PIC16(L)F18856/18876 Family Silicon Errata and Data Sheet Clarification

The PIC16(L)F18856/18876 family devices that you have received conform functionally to the current Device Data Sheet (DS40001824A), except for the anomalies described in this document.

The following typographic corrections and clarifications are to be noted for the latest version of the device data sheet (DS40001824A):

FIGURE 32-14: TIME OF FLIGHT MODE REPEAT ACQUISITION TIMING DIAGRAM

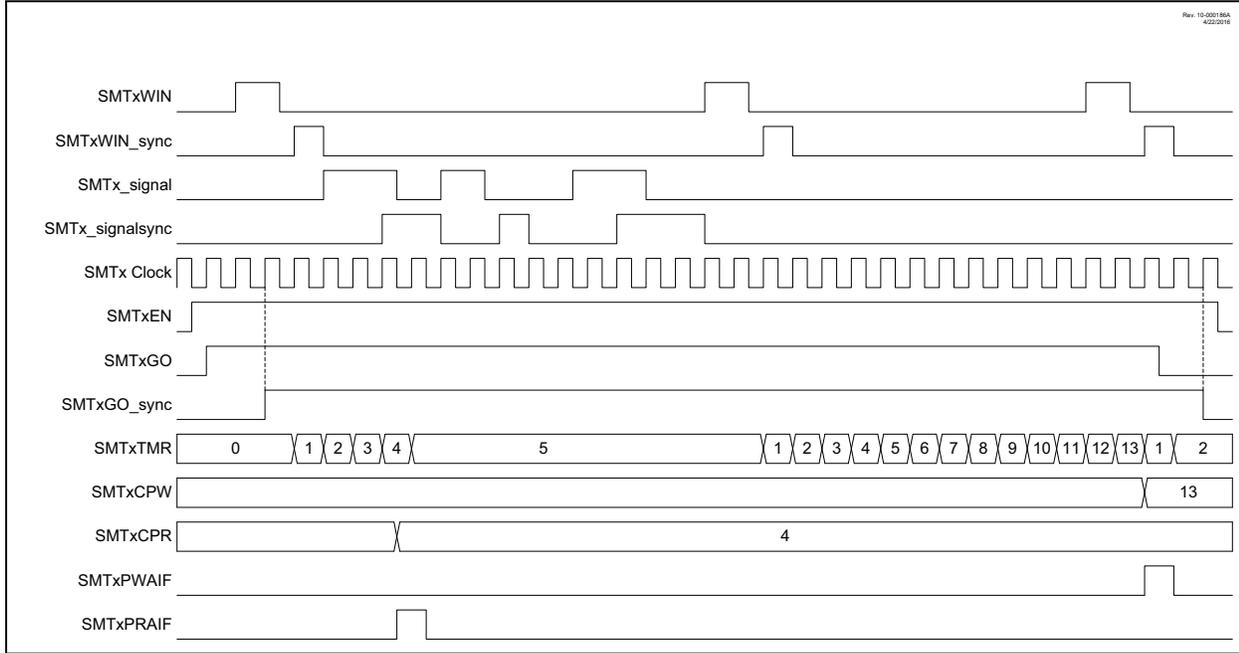
Several timing diagrams in the Signal Measurement Timer chapter (namely Figures 32-14, 32-15, and 32-18) contain inaccuracies. The correct versions of these timing diagrams are below.

FIGURE 29-3: TIMER2 PRESCALER POSTSCALER, AND INTERRUPT TIMING DIAGRAM

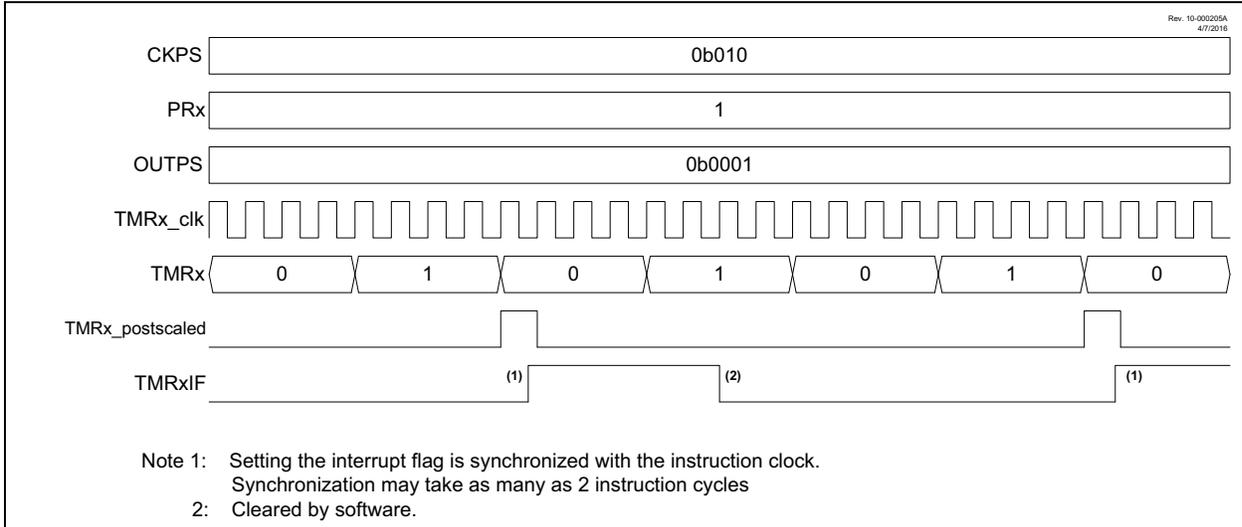
Several timing diagrams in the Timer2/4/6 chapter (namely Figure 29-3, as well as Figures 29-8 through 29-13) contain inaccuracies. The correct timing diagrams are shown below.

FIGURE 23-2: ANALOG-TO-DIGITAL CONVERTER WITH COMPUTATION (ADC²)

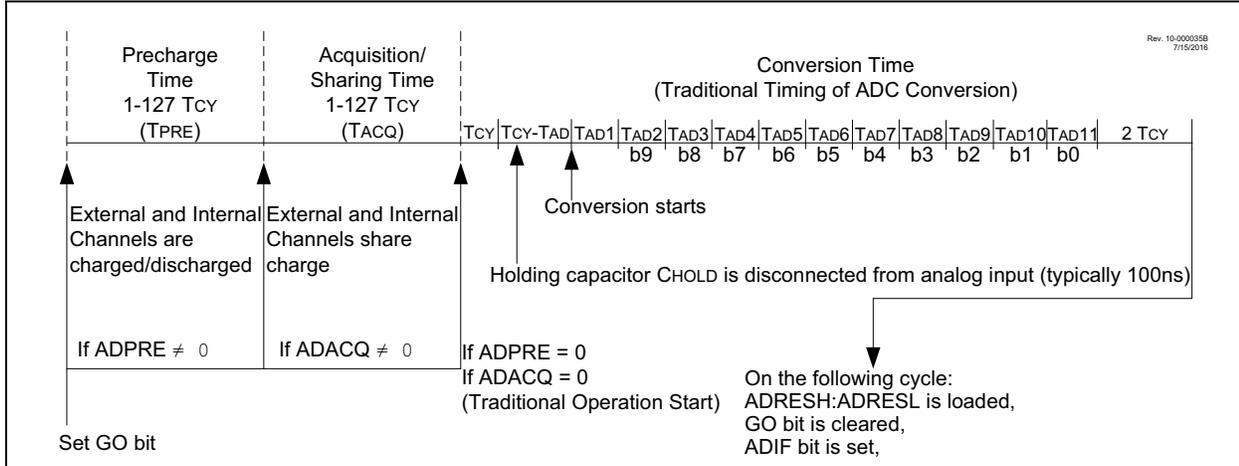
Figure 23-2: Analog-to-Digital Converter with Computation (ADC²) is inaccurately described in the data sheet for the ADCC. It should be as follows:
